工程指示 / 要求簡箋(E.I.)

工程指示編號：EI / 9229 / 25 修改版次：
 工程編號：J - 858 工程名稱：將軍澳日出康城
 工程項目：幕牆 第 14 次 補玻璃 11 件 (小業主單)
 收件人：Maggie 發件人：Jason 日期：21/11/2025

由於地盤需要更換玻璃，請按玻璃 BM 生產玻璃，共 11 件 送地盤。
請安排熱浸

AL01-14

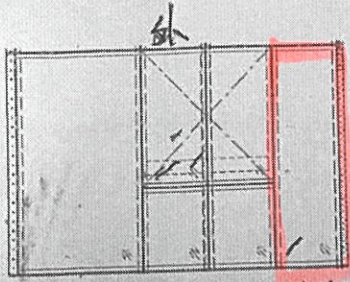
外換

待料 12/11

外崩花, **57 AA**房**1**大梗

6101-14

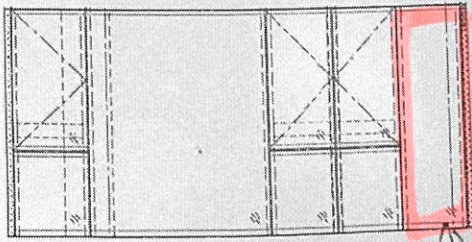
採

CW4
T3B
GL01-23

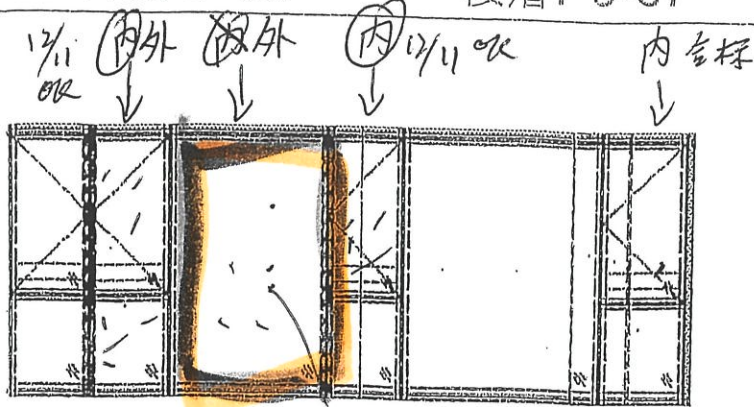
↓ 崩
2x3mm
2x mm

大深磨不到
化料換

泡
1x1m

磨 牌點, 崩多磨不到
化料換

← 由 化料換

01

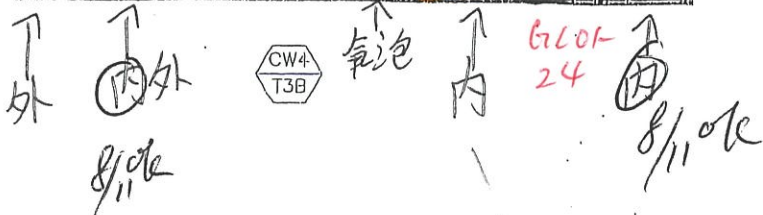
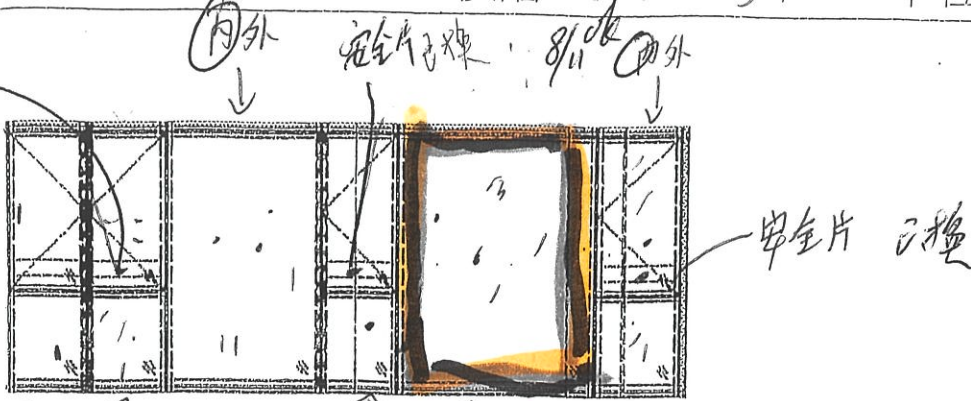
已換

崩位太深磨到
主大梗化料換

內
GL01-24

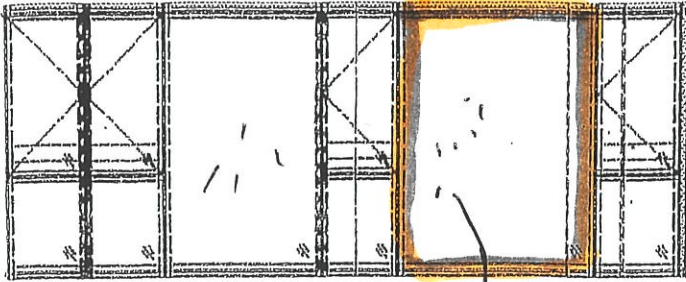
5/11 外
OK

多處以花

安全片全合標

← 化料換
